2019-05-29

Subject: 91 and 131 Eglinton Avenue East, and 5055 Hurontario Street Transportation Study - Response to Comments

A Transportation Study was completed by WSP for the subject lands in September 2018 along with a Technical Memo regarding the Belbin Street extension, dated June 2018. Subsequently, comments were received from the City of Mississauga, dated February 6th, 2019, which are provided in **Attachment 1**. WSP discussed the transportation comments with the City on March 16, 2019 and the approach for addressing them. The brief synopsis of the discussion is provided in **Attachment 2**. All comments directly related to the September 2018 Transportation Study and June 2018 Technical Memo, as well as comments regarding waste collection (below in red) have been addressed within this letter. The contents of this letter are based on the latest site plan, dated April 24th, 2019, which is provided as **Attachment 3**.

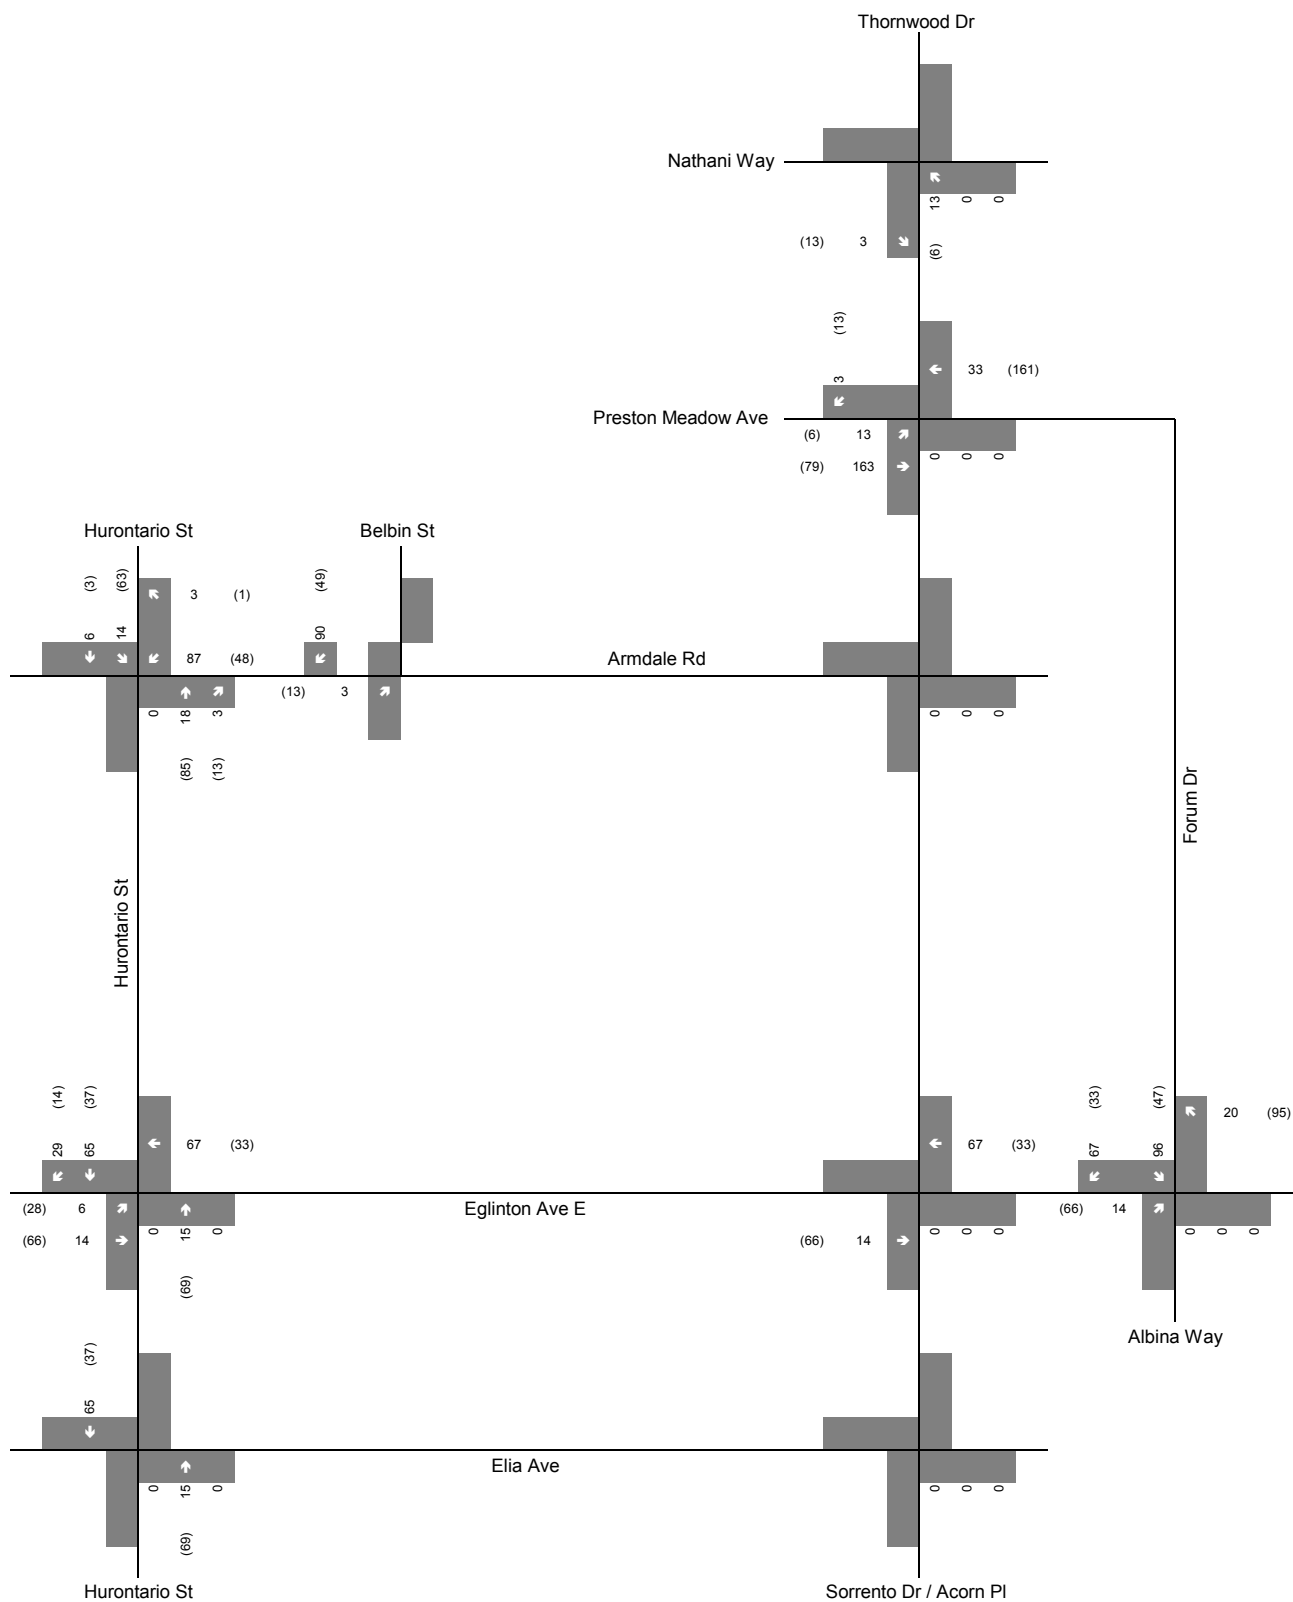
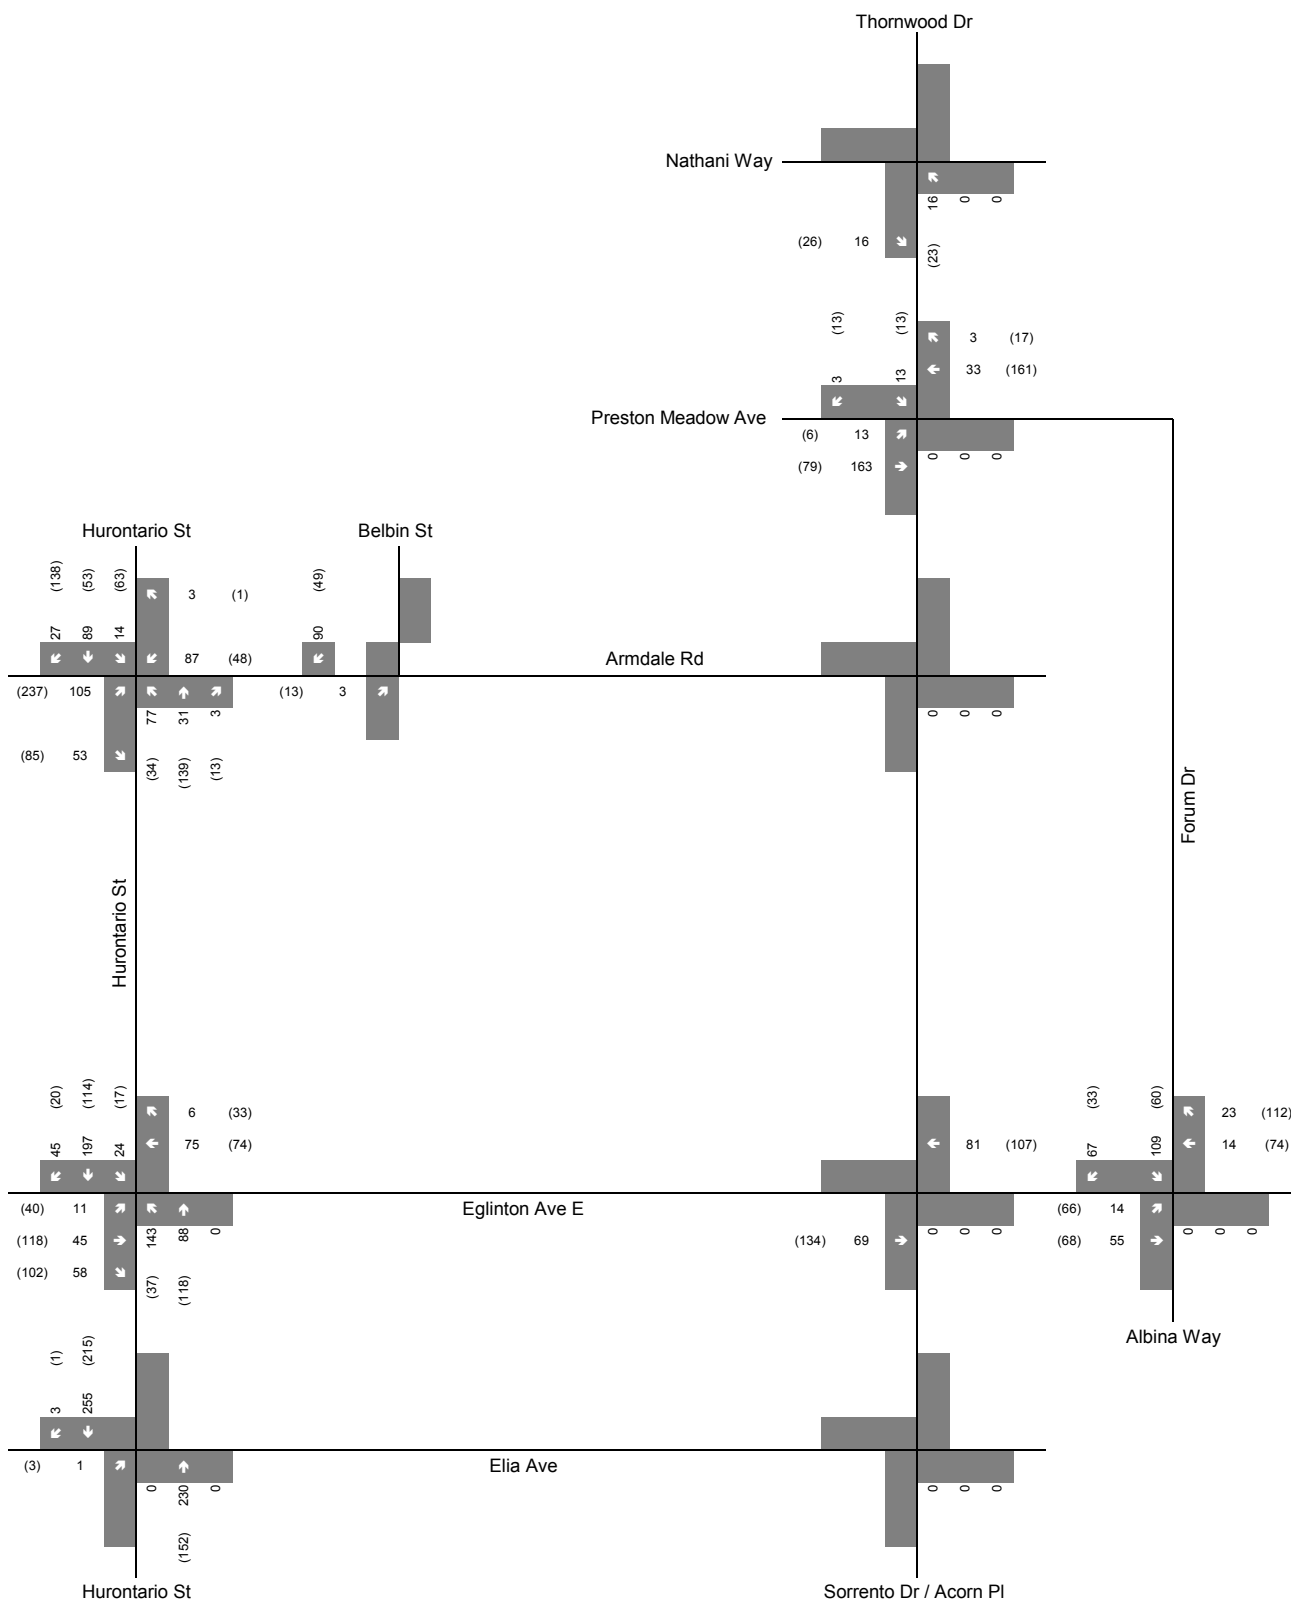
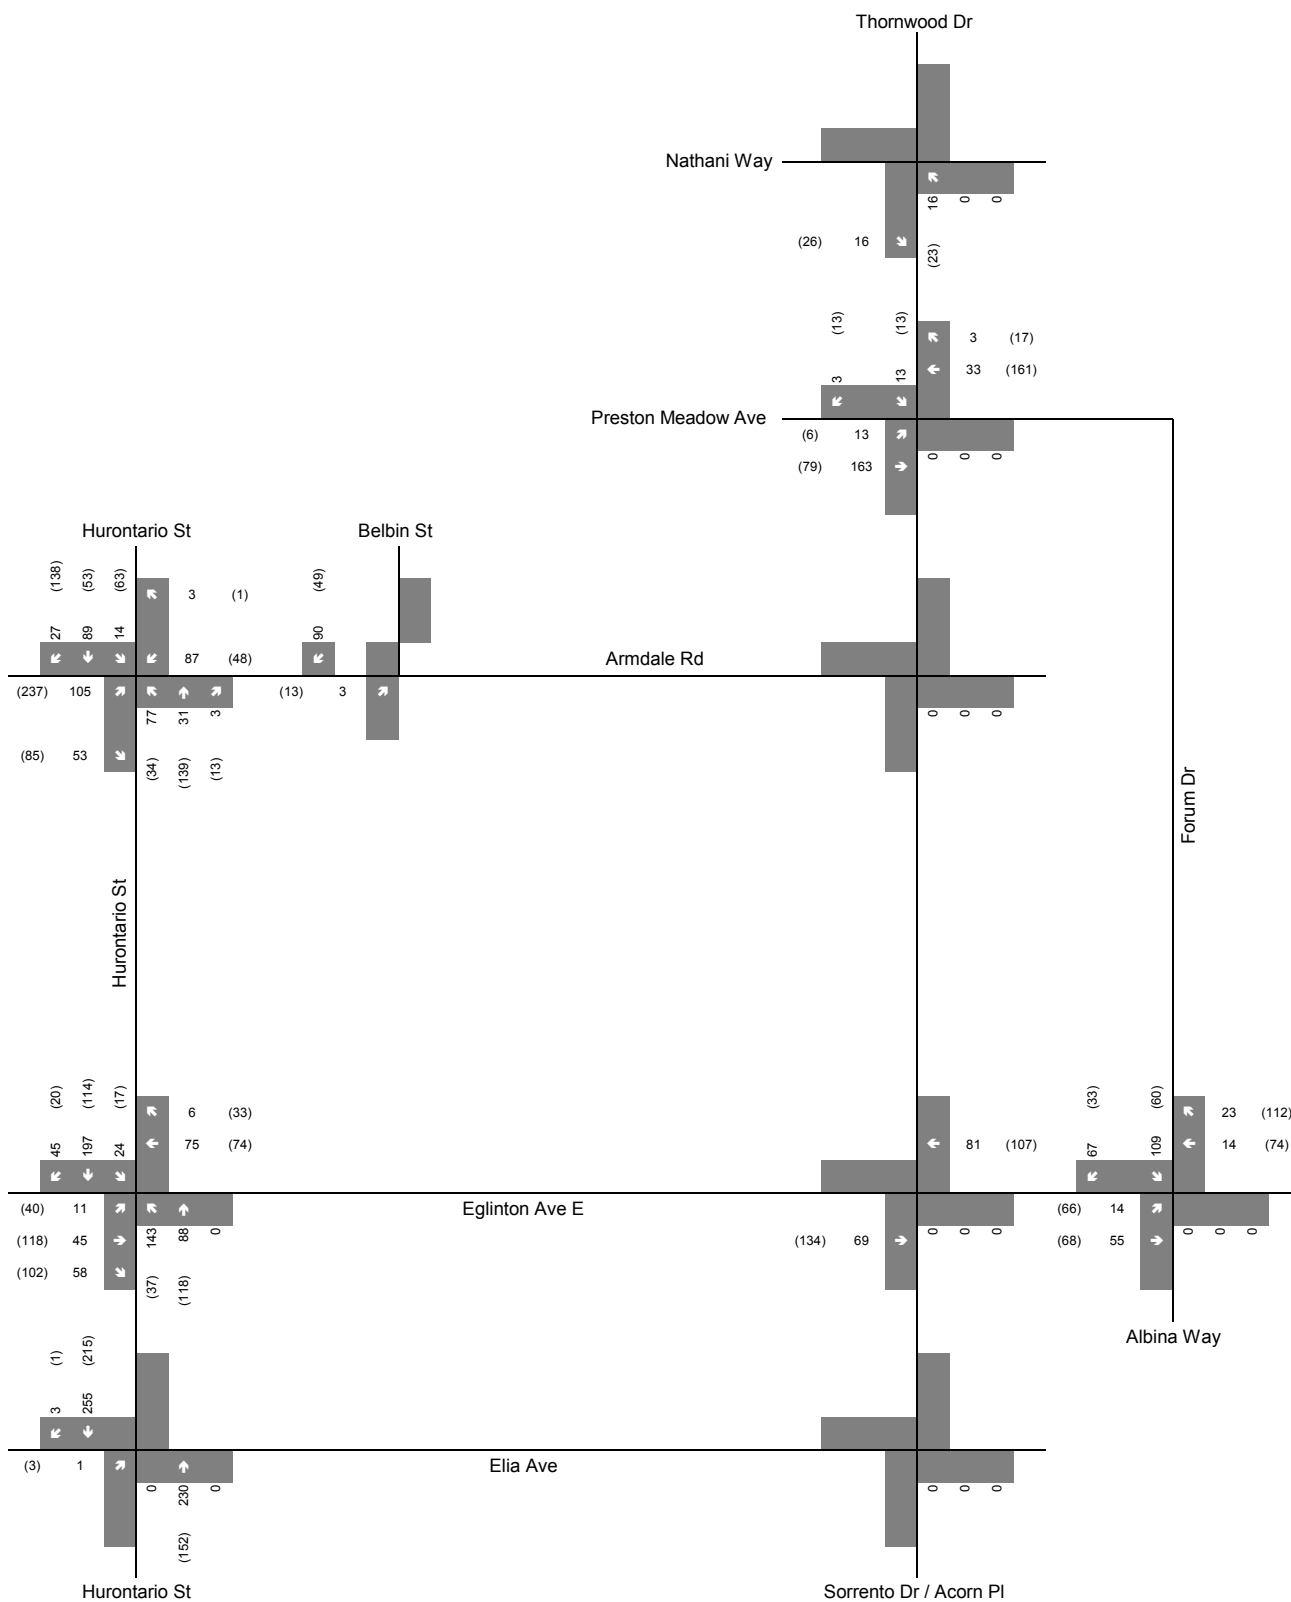
- d. Traffic volume diagrams for background developments shall be provided separately from the total background traffic diagrams;*

Traffic volume diagrams for the individual background developments included in the study are provided as **Figures 8 to 11 of Attachment 5**.

Figure 12
Sightline Analysis - Proposed Access on Future Thornwood Drive
91 Eglinton Avenue East

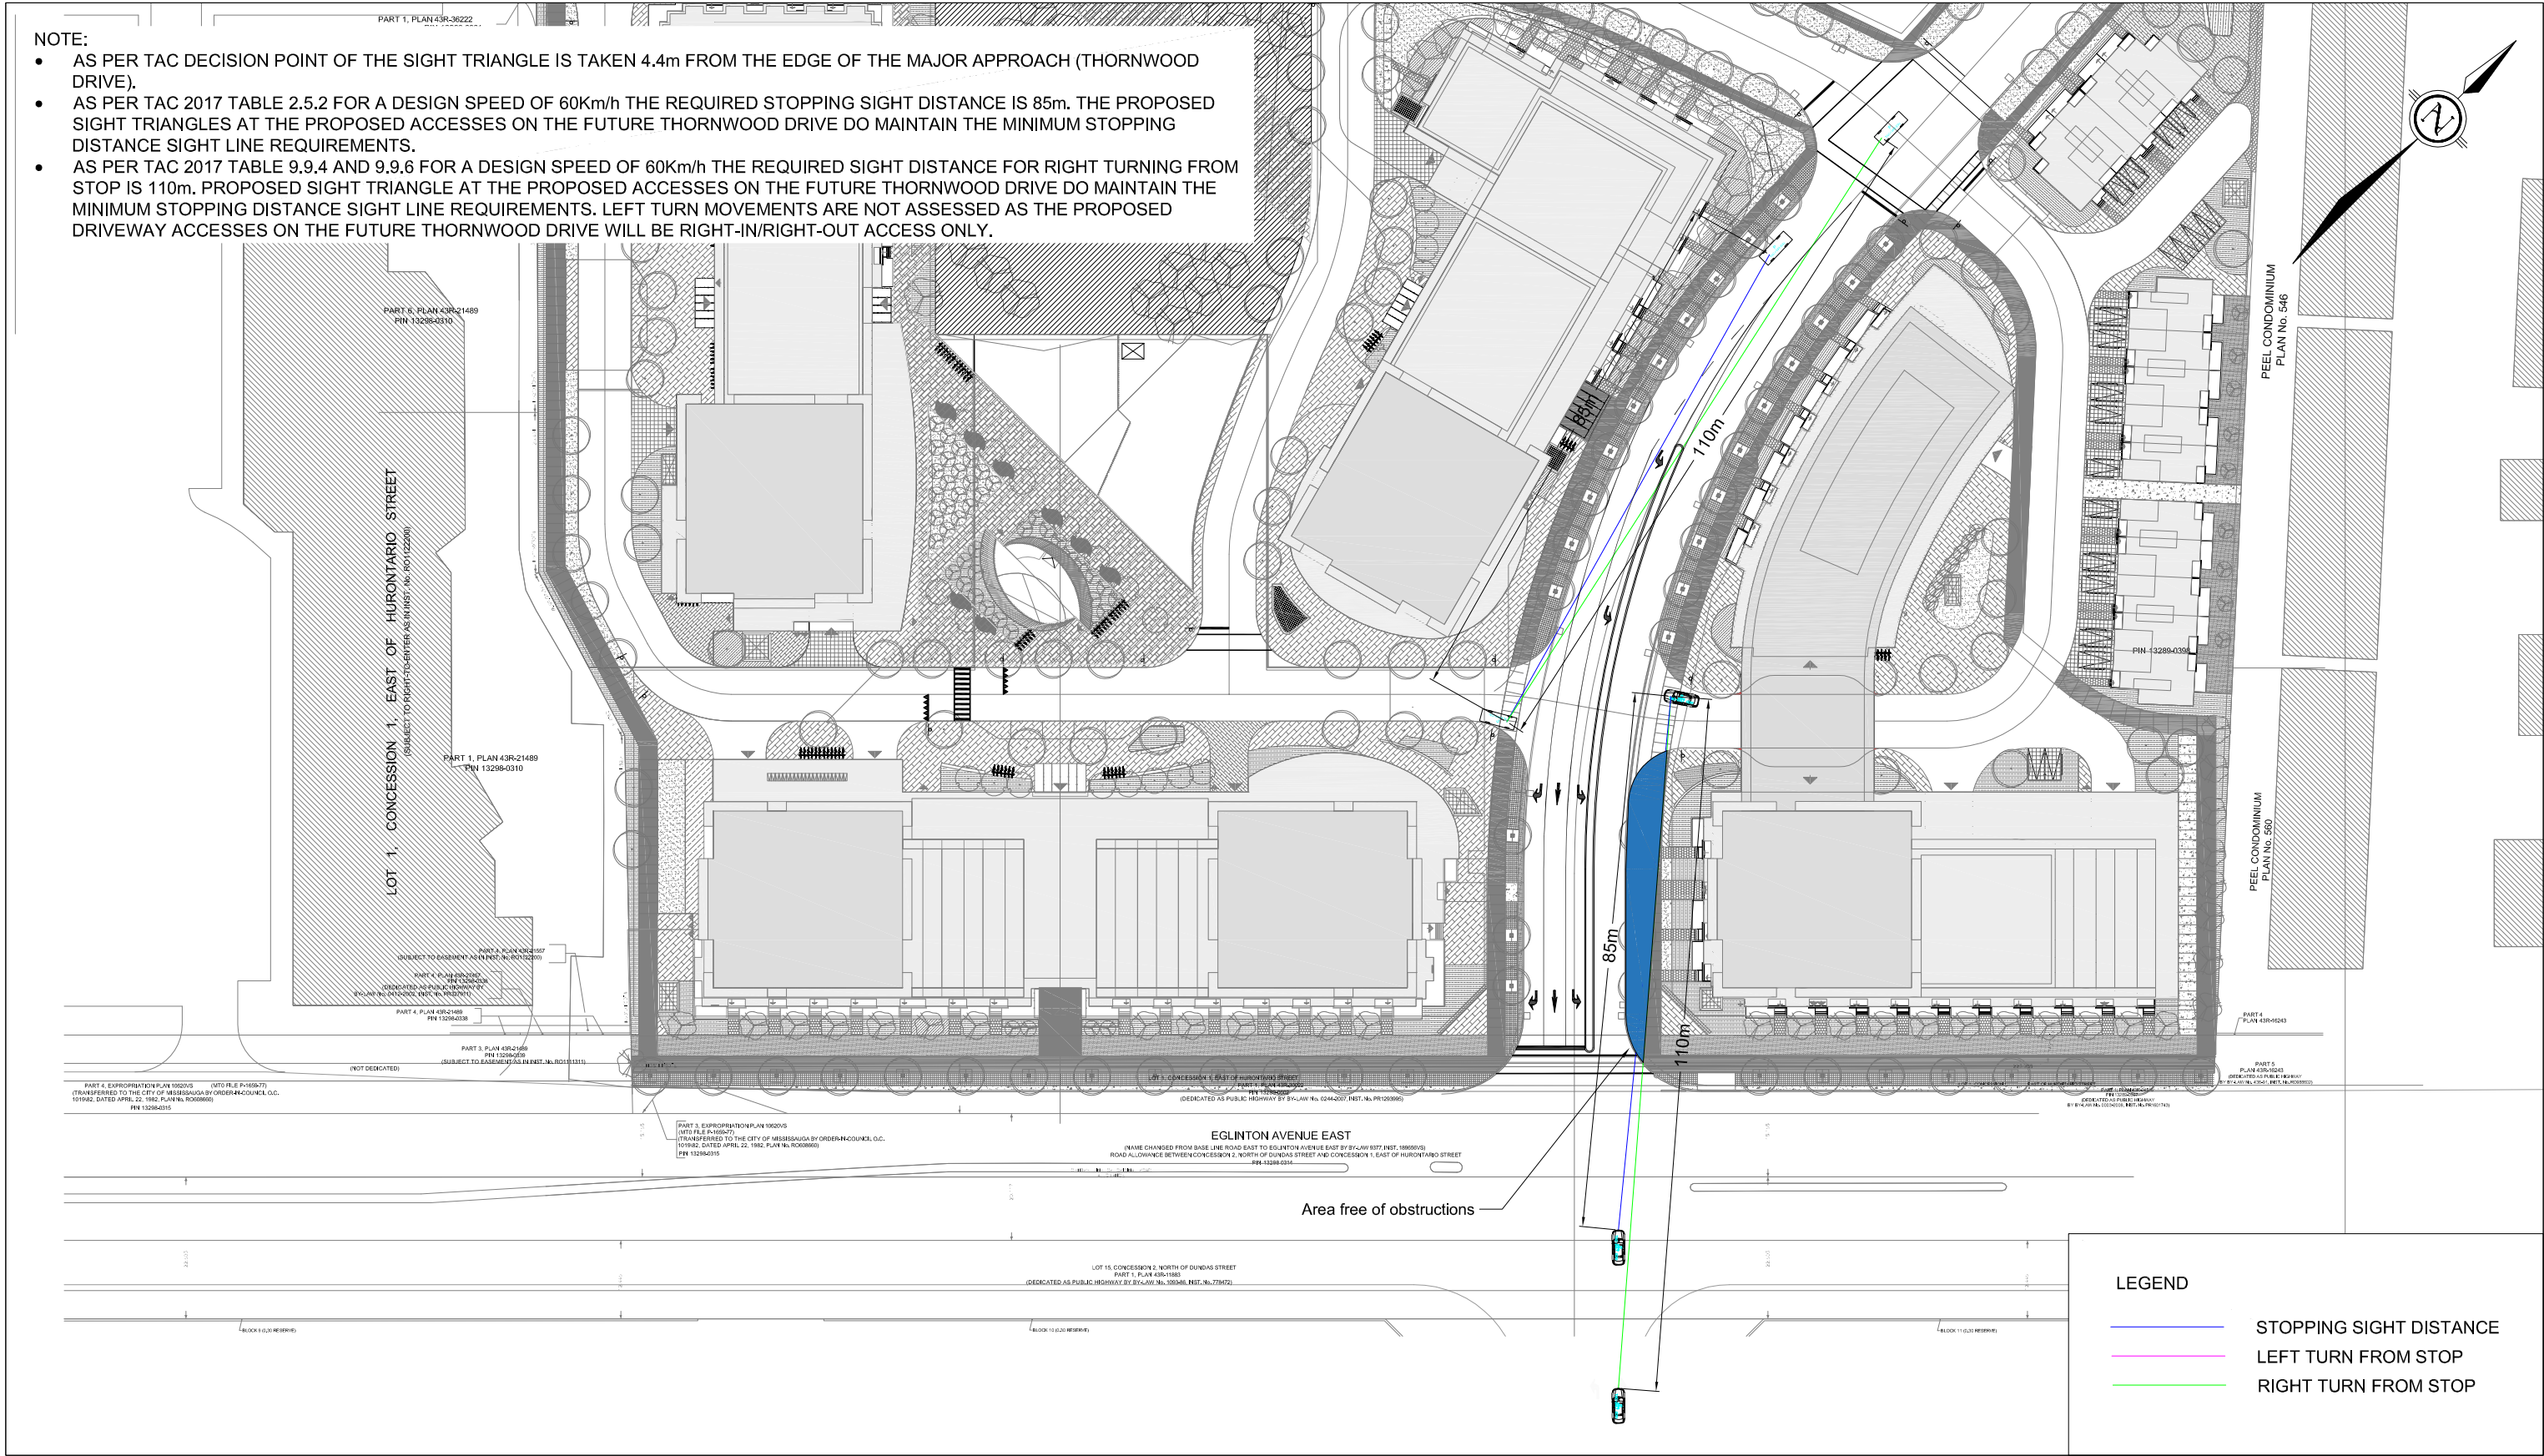
All landscaping and grading within close proximity to the proposed access points is to be designed to ensure that adequate sight distances are available for all approaching and exiting motorists and pedestrians;

Figures 12-14 of Attachment 5 identifies hatched areas that need to be kept clear of all sight line obstructions. Based on TAC Section 8.9.3 it is not necessary to eliminate landscaping from the vicinity of the driveways to provide the required sight distance. Ground cover planting and low shrubs, or trees with high canopies, can be used effectively without affecting the sight lines of the driver.
